ADDENDUM NO. 1

August 3, 2023

Geiger House
2631 Gilbert Avenue
Cincinnati, OH 45206

Emboss Design (formerly PCA)
906 Monmouth Street
Newport, KY 41071

ENLARGED PLANS

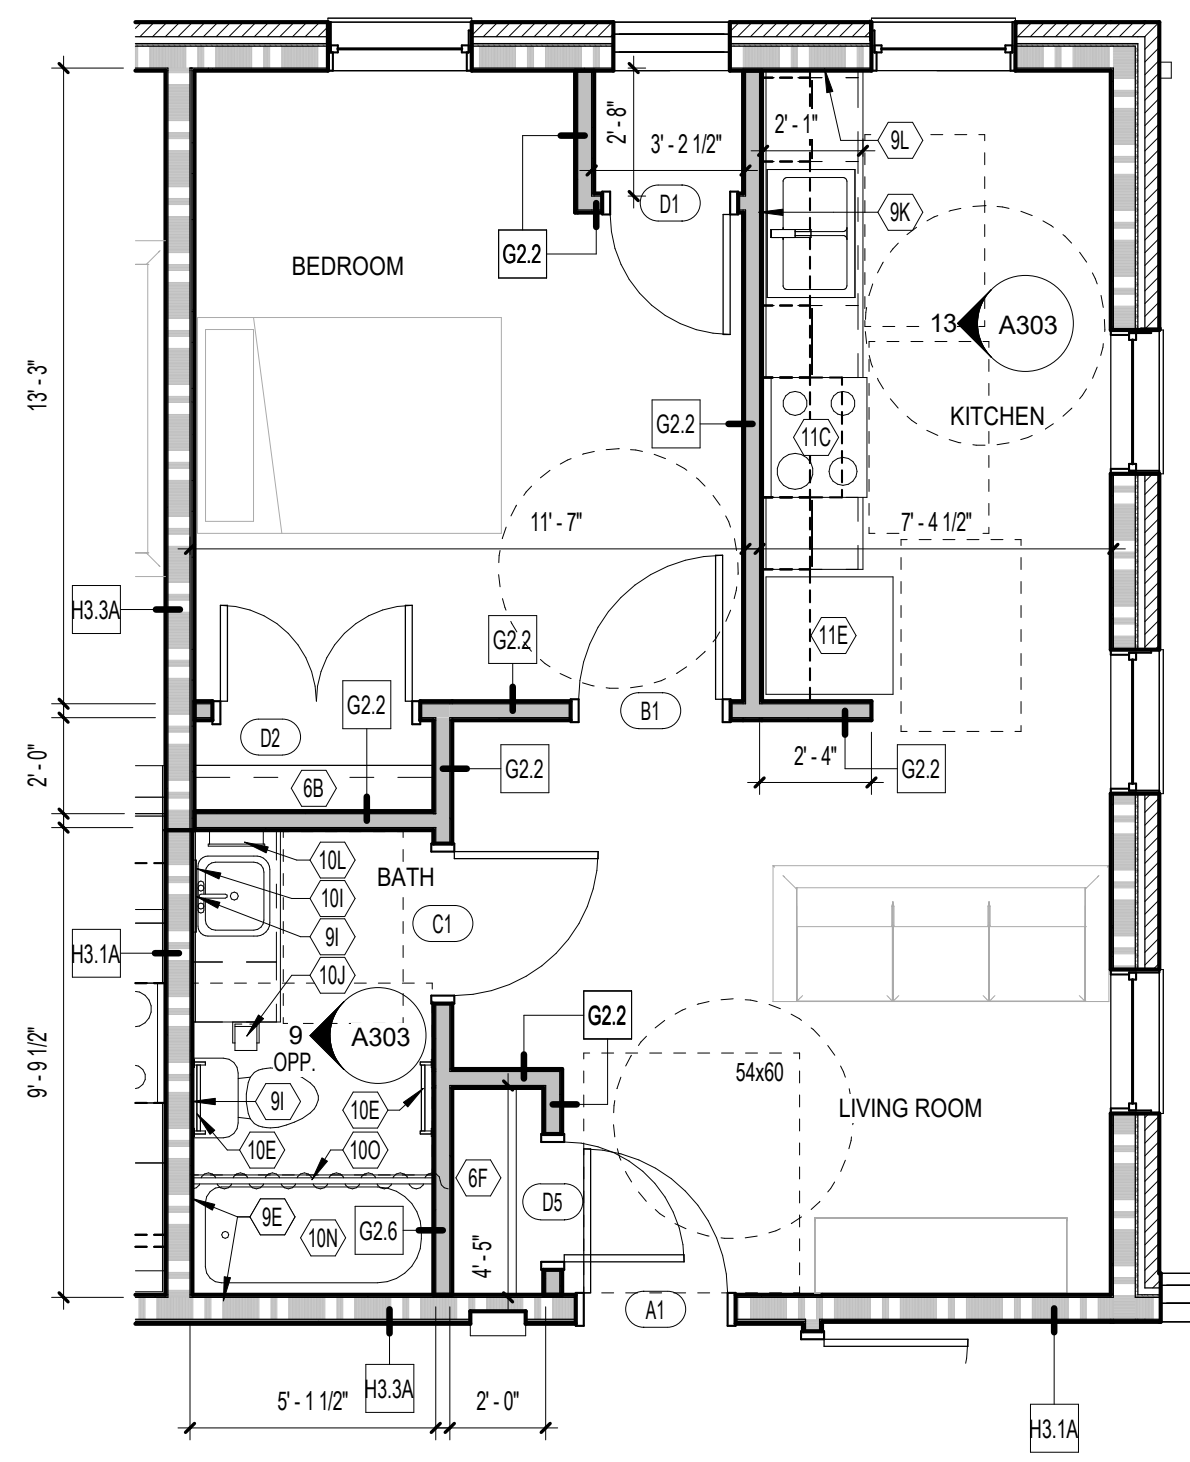
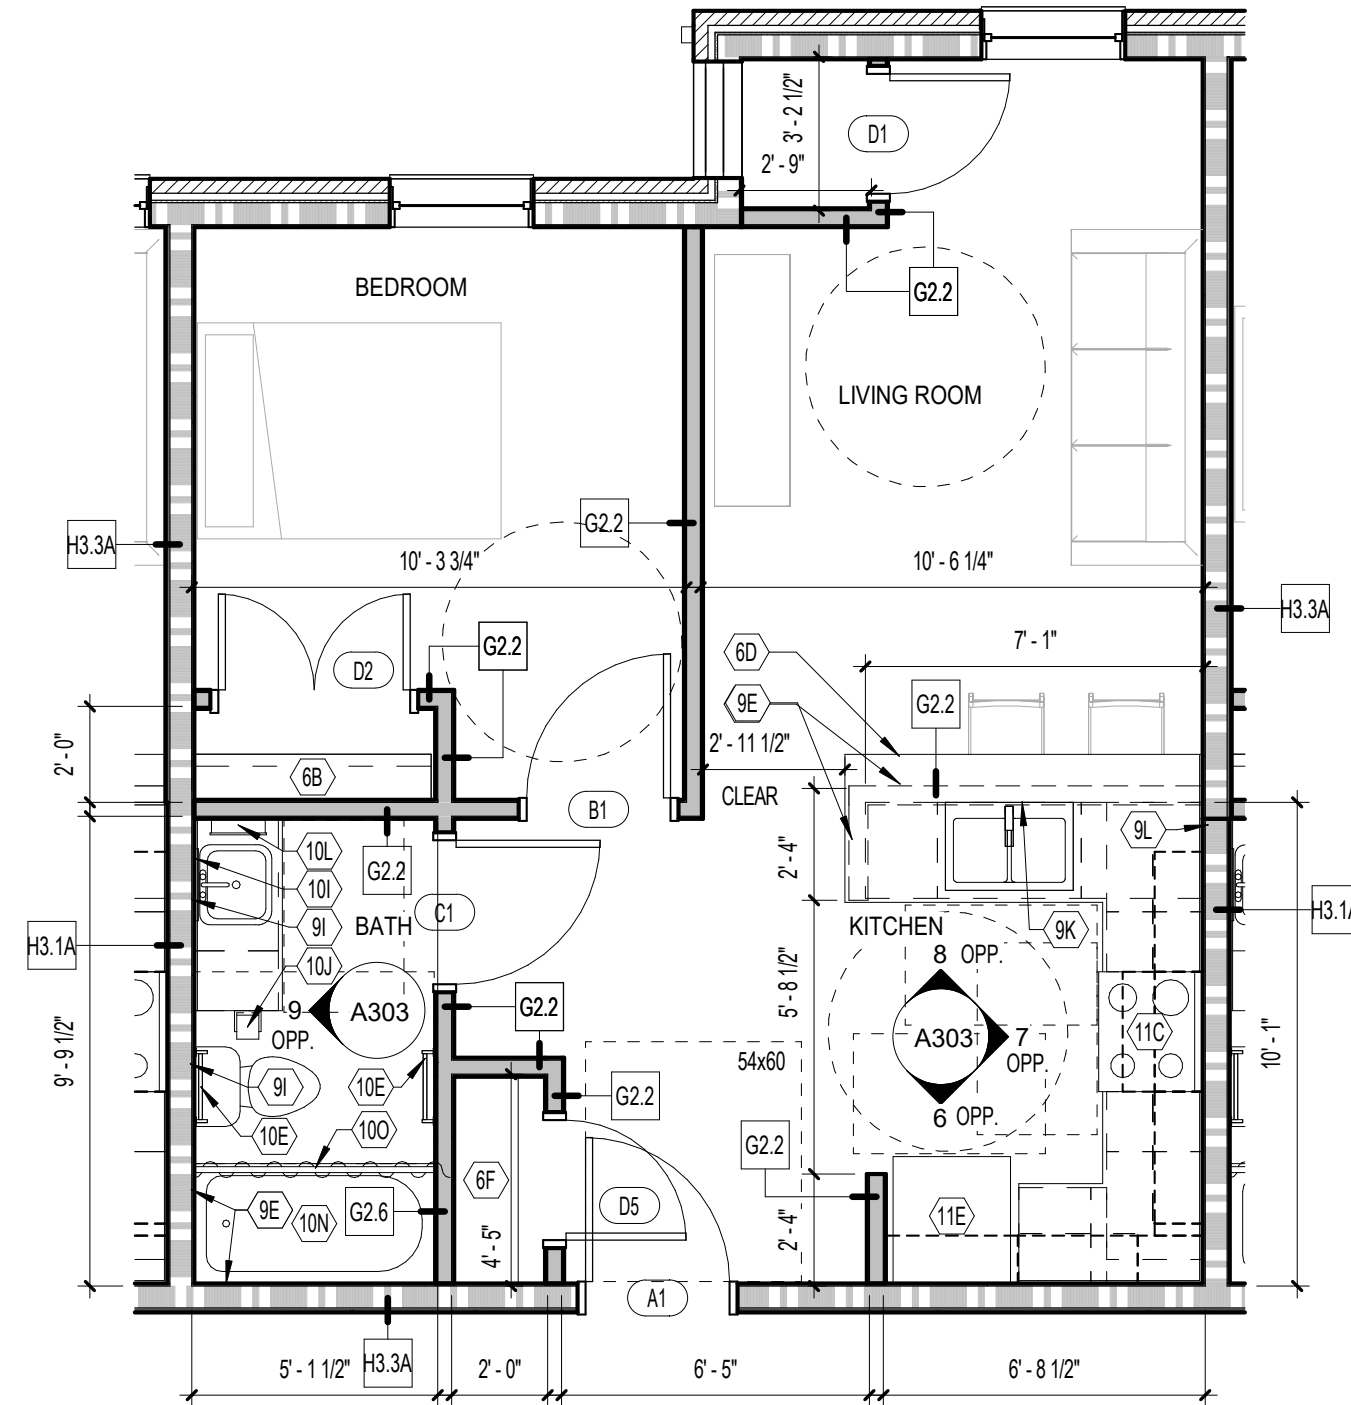
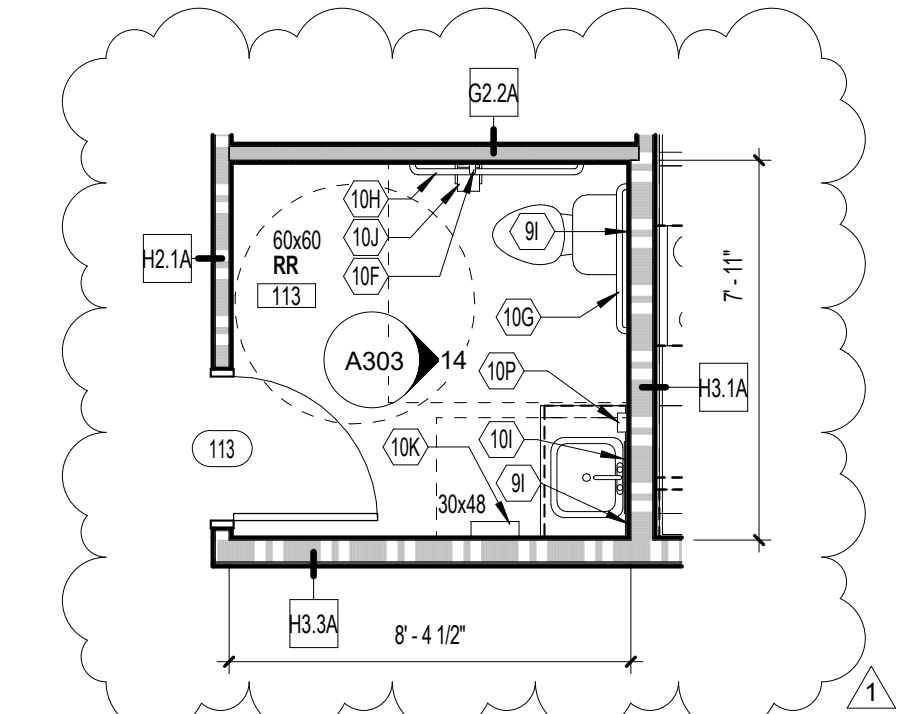
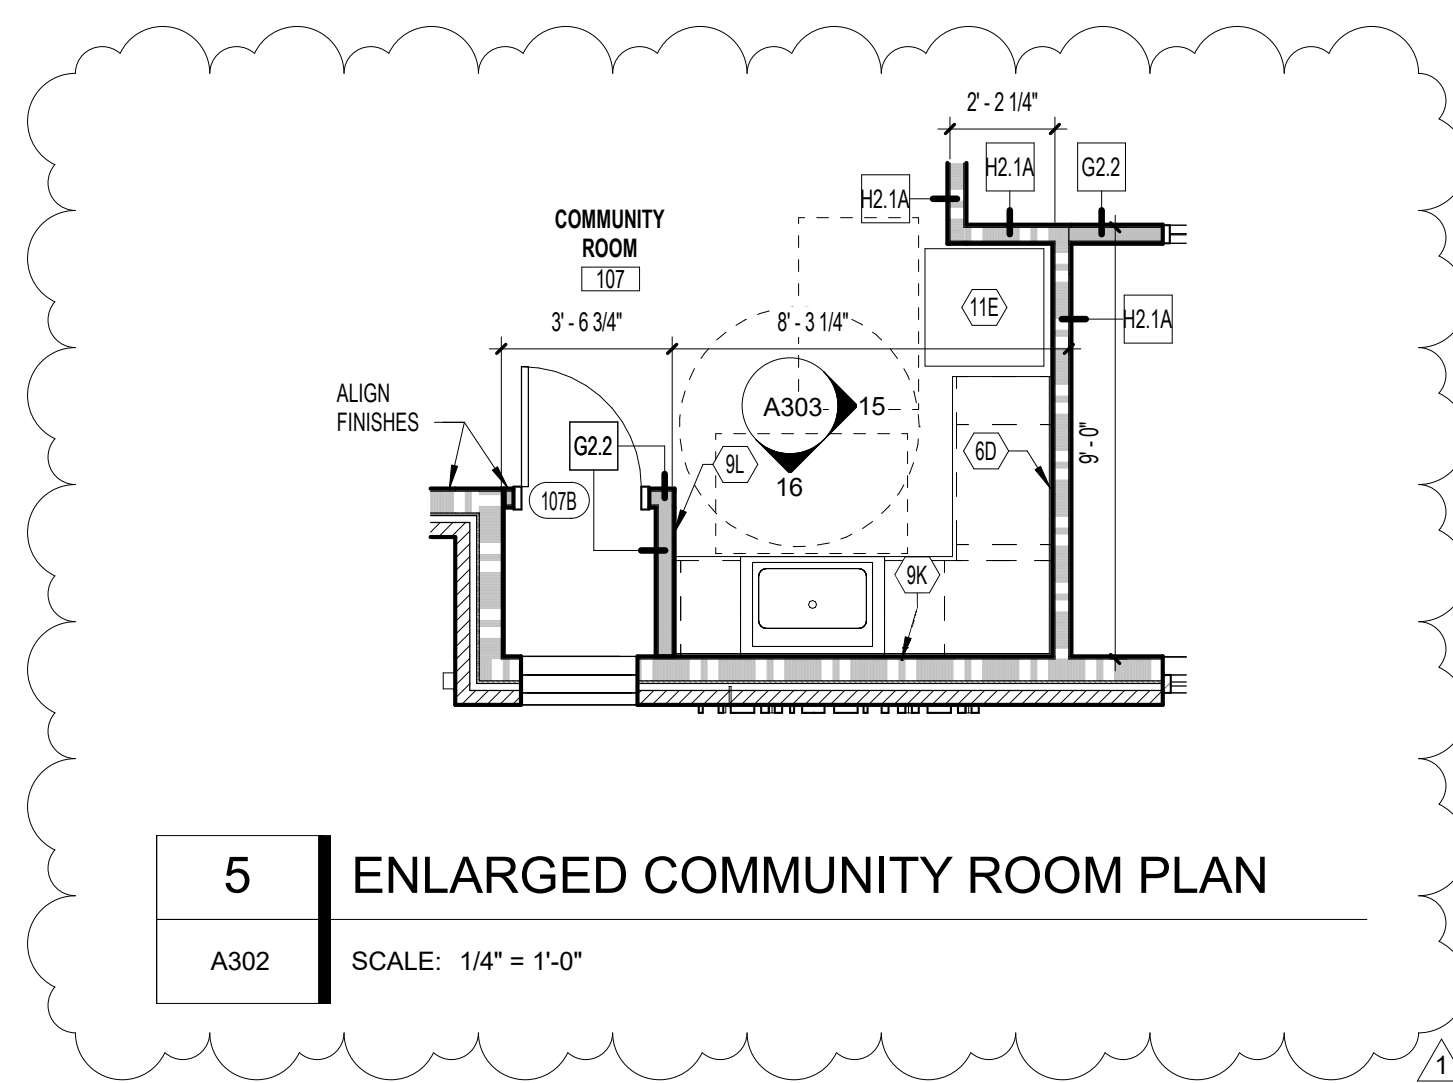
5. A302 ENLARGED PLANS

- Revised sink type in RR 113 and enlarged room 3 ¾" to the North
- Added enlarged community room kitchenette plan to sheet

INTERIOR ELEVATIONS

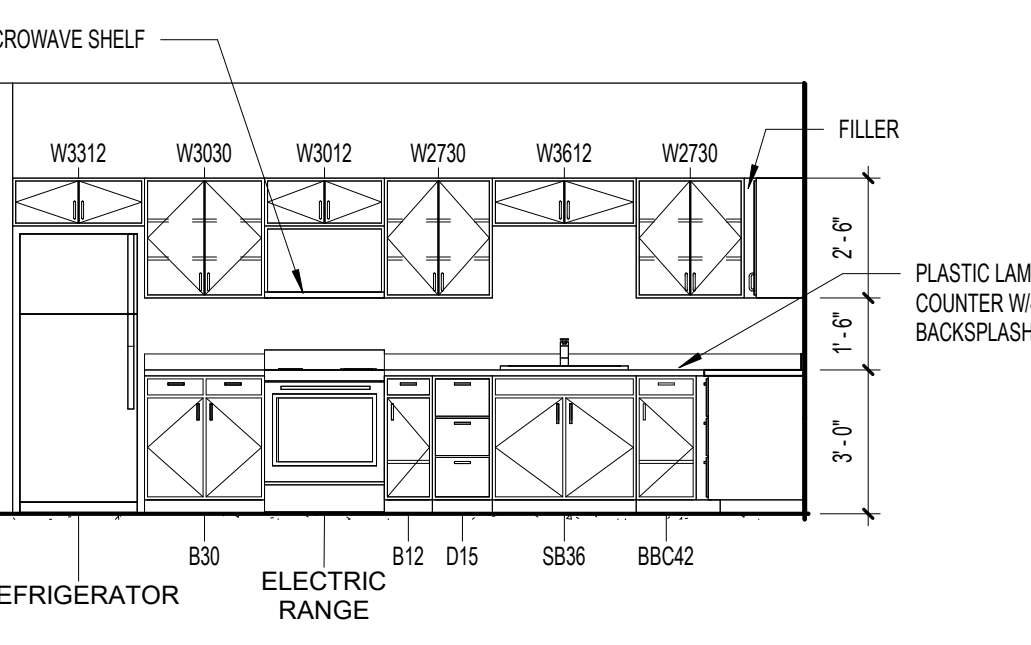
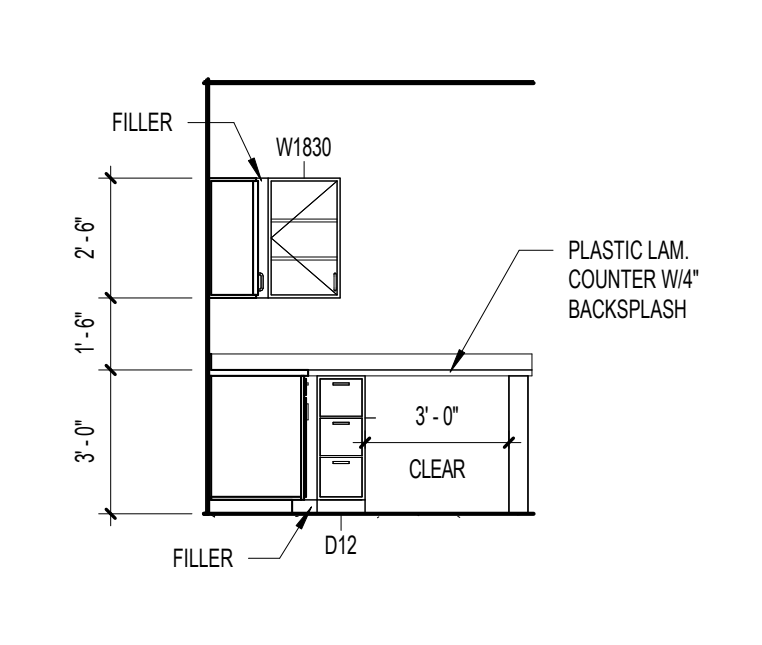
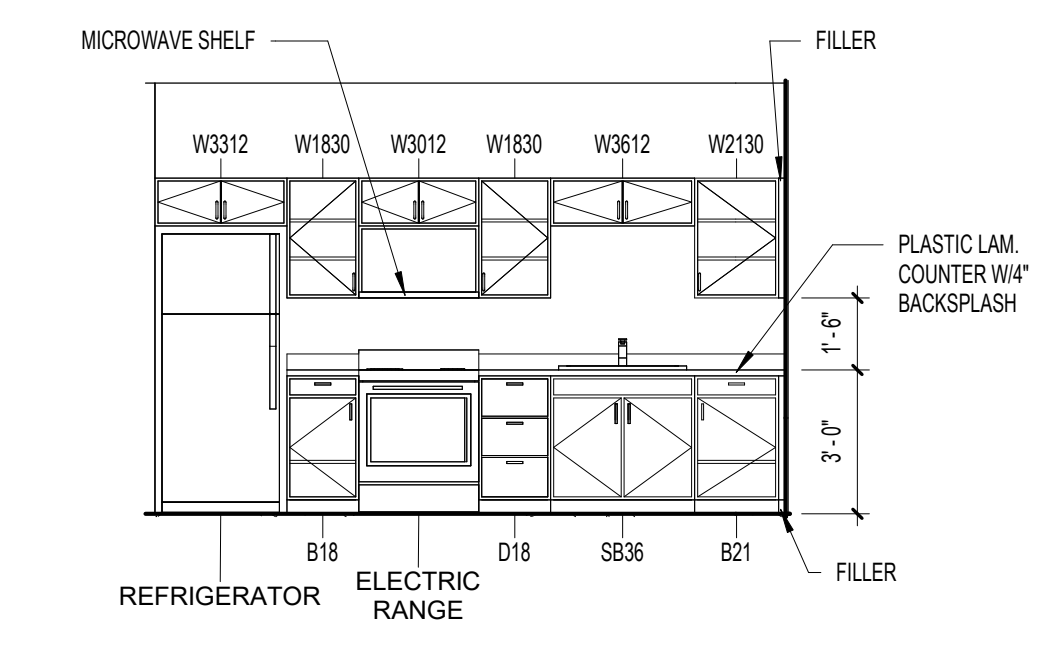
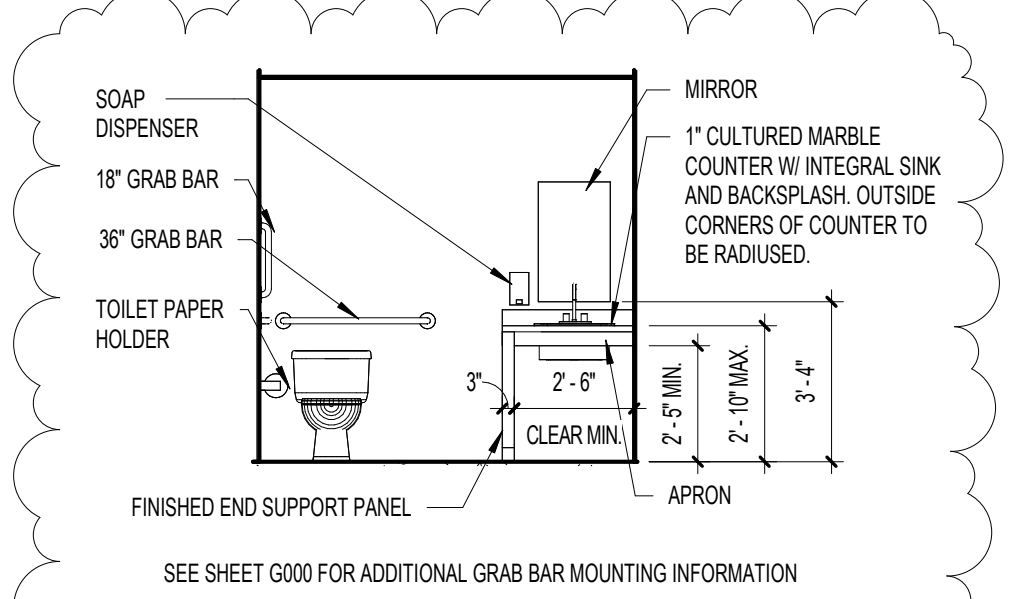
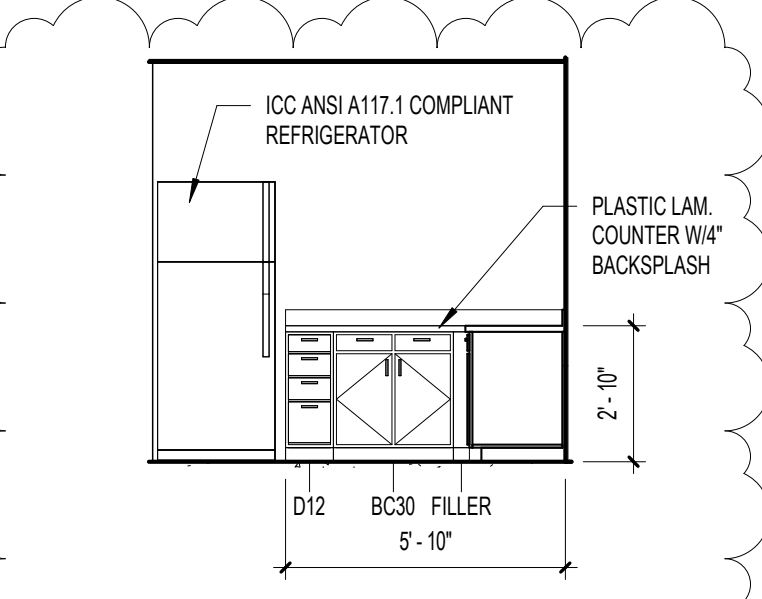
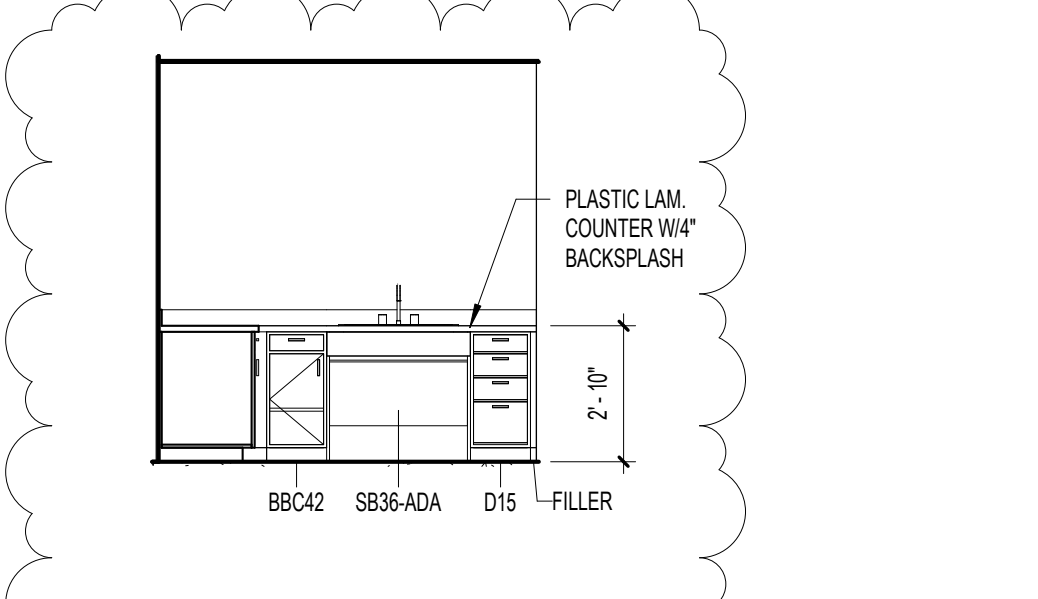
6. A303 INTERIOR ELEVATIONS

- Added notes for outside corners to be radiused in response to OHFA review comment.
- Added elevation for Restroom 113 showing revised sink
- Added elevations for Community Room Kitchenette
